DENVER NEPHROLOGY  
1411 S. POTOMAC, SUITE 200  
AURORA, CO

City of Aurora Building Division  
Reviewed for Code Compliance  
Approved as Noted: **Y. Munoz**  
Date: **Mar 25, 2016**  
2015 INTERNATIONAL CODES & 2014 NEC

RSN: 1095504  
Permit #: 16-1076410 LT

WASTE AND VENT ISOMETRIC

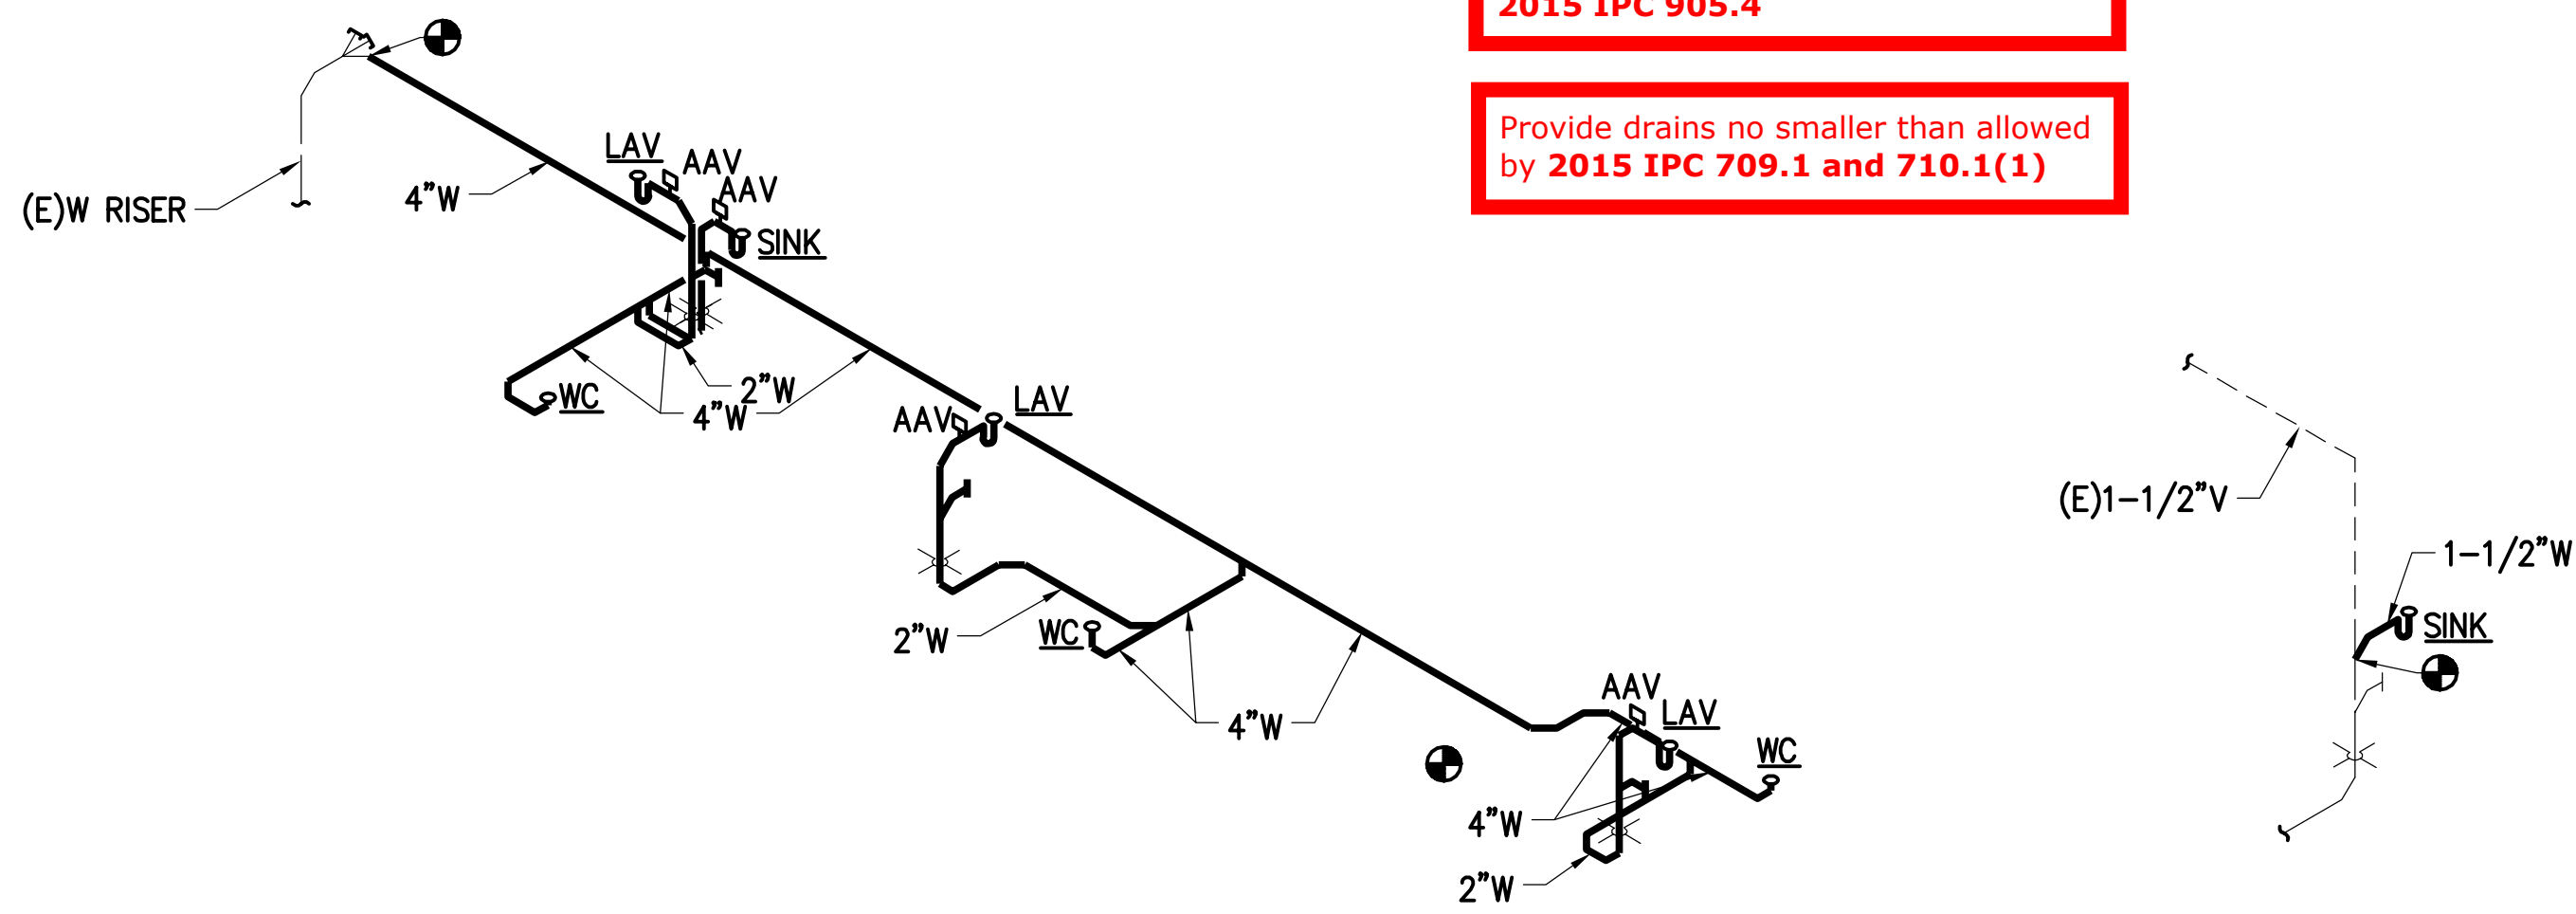
The dry vent must rise 6" vertically above the flood level rim of the highest trapped fixture being vented.  
2015 IPC 905.4

Provide drains no smaller than allowed by 2015 IPC 709.1 and 710.1(1)

PLUMBING FLOORPLAN

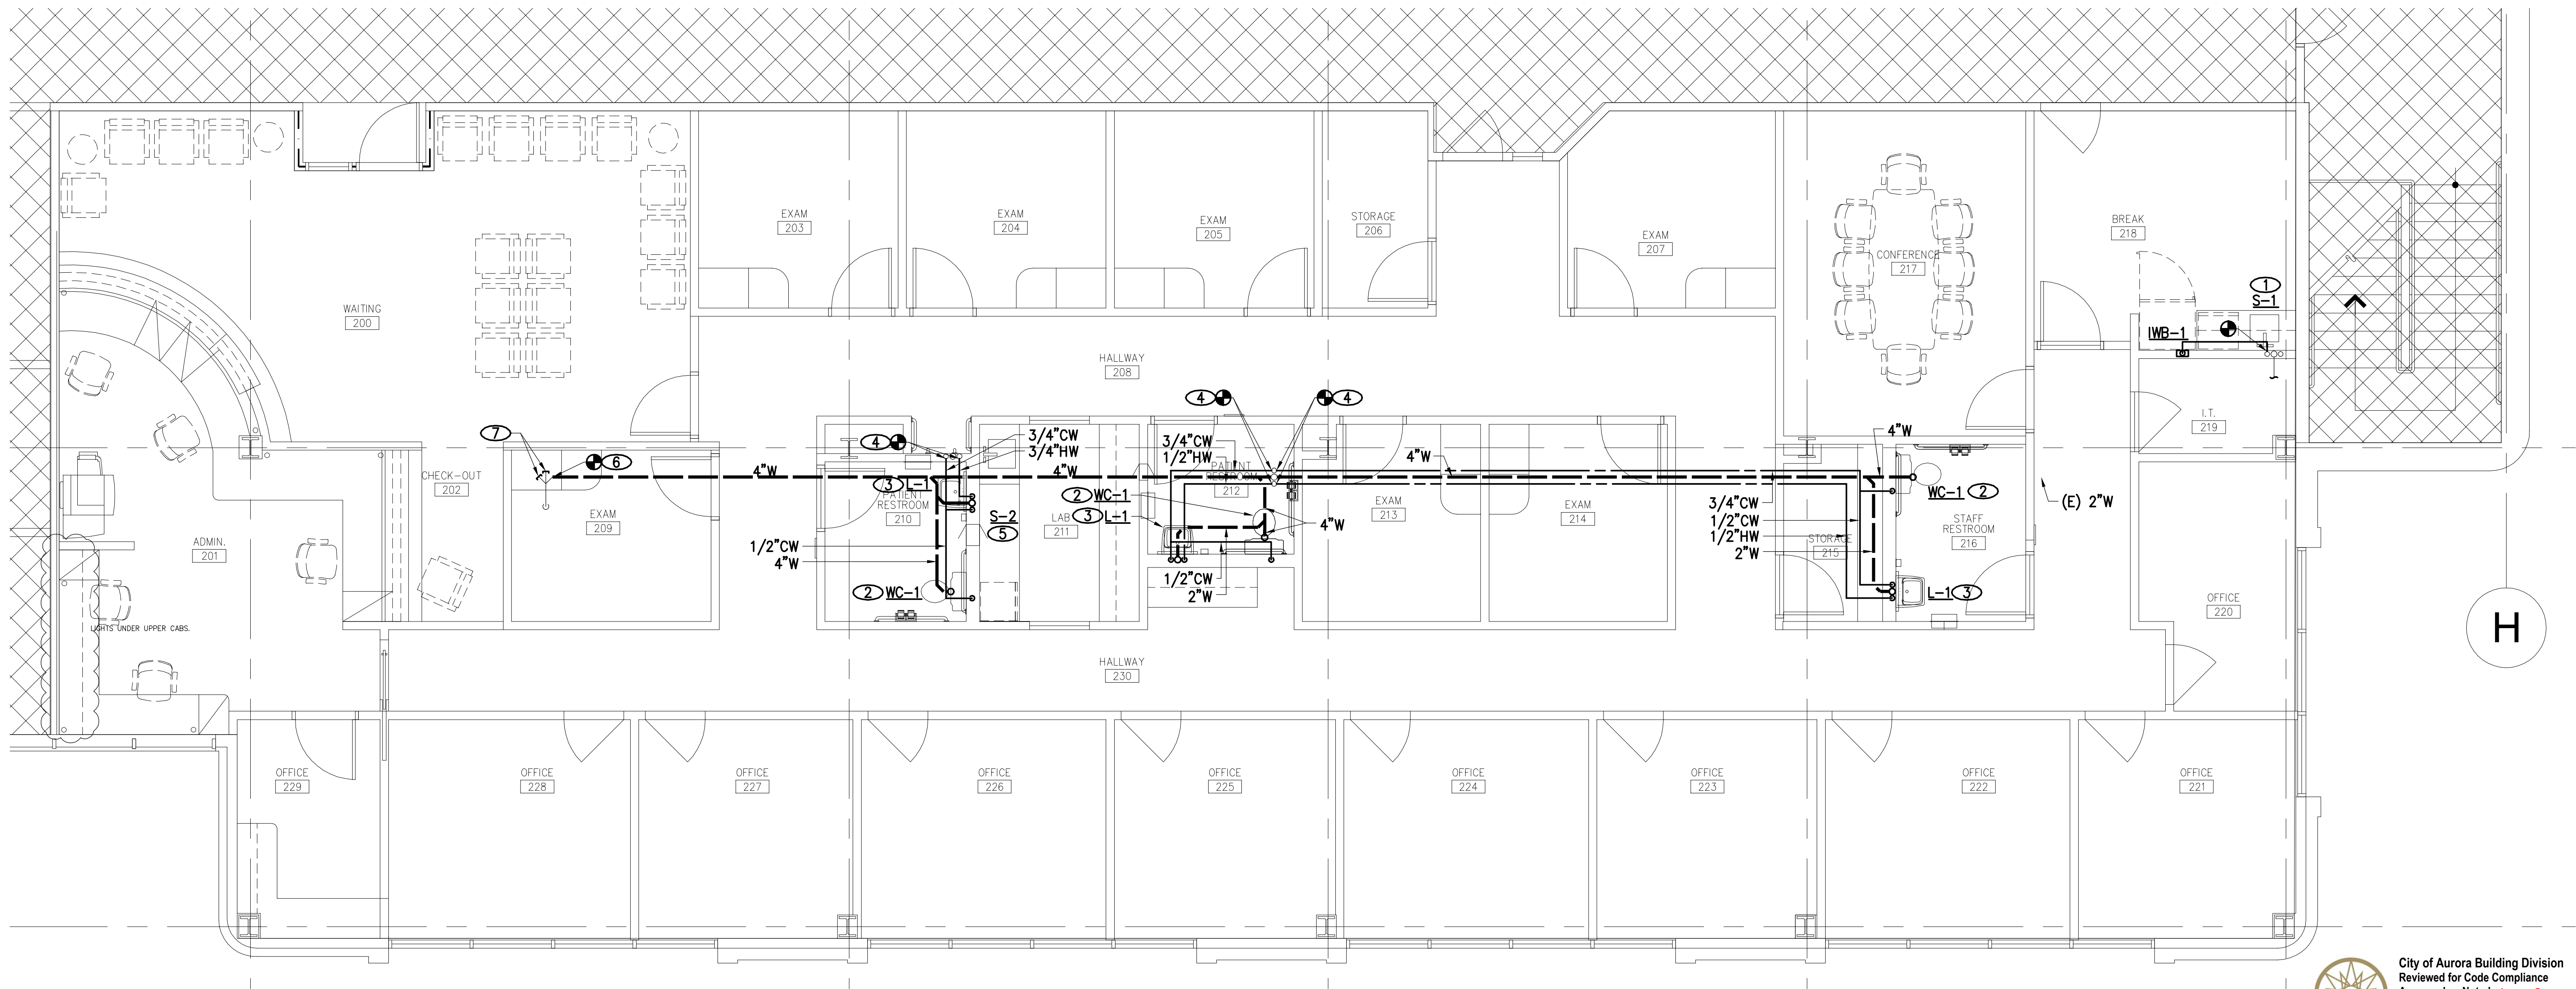
Failure to follow the approved plans may result in an hourly fee to review the field changes for code compliance.

Directional signage indicating the route to public restroom facilities shall be posted. The sign shall be located in a lobby, corridor, aisle or similar space such that it can be seen from the main entrance. 2015 IPC 403.4.1
